Amendments to the Drawings

Remarks

FIG. 3

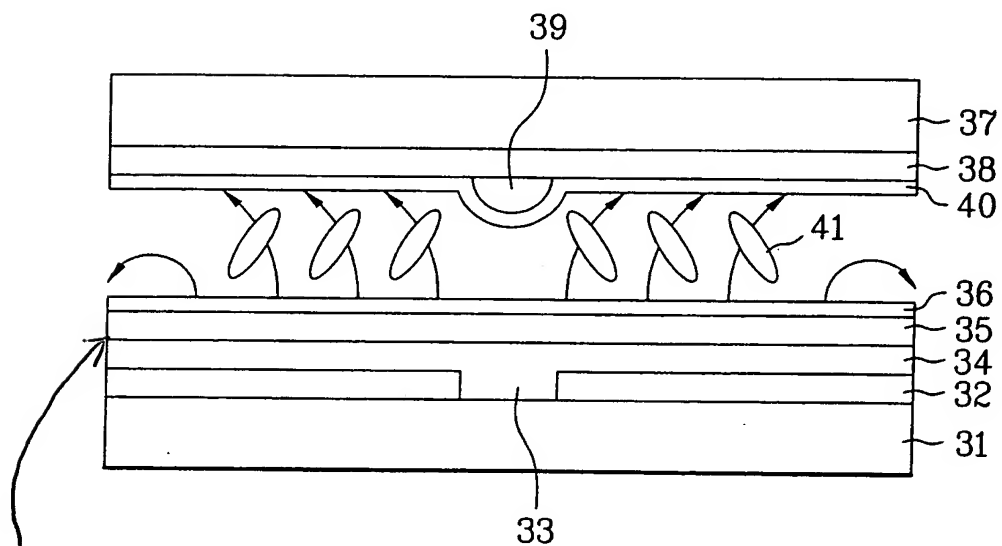
Fig. 3 has been amended to show the location of a thin film transistor and passivation layer feature.

The drawing is objected to under 37 CFR §1.83(a) for not showing every feature in the claims. This objection is respectfully traversed.

Nevertheless, Applicants have amended Fig. 3 to show the location of a TFT and a passivation layer, as described in paragraph [0040], for example,

showing the recited TFT as a labeled representation because a more detailed illustration is not needed for a proper understanding of Applicants' claimed invention. No new matter is involved.

TFT & Passivation Layer
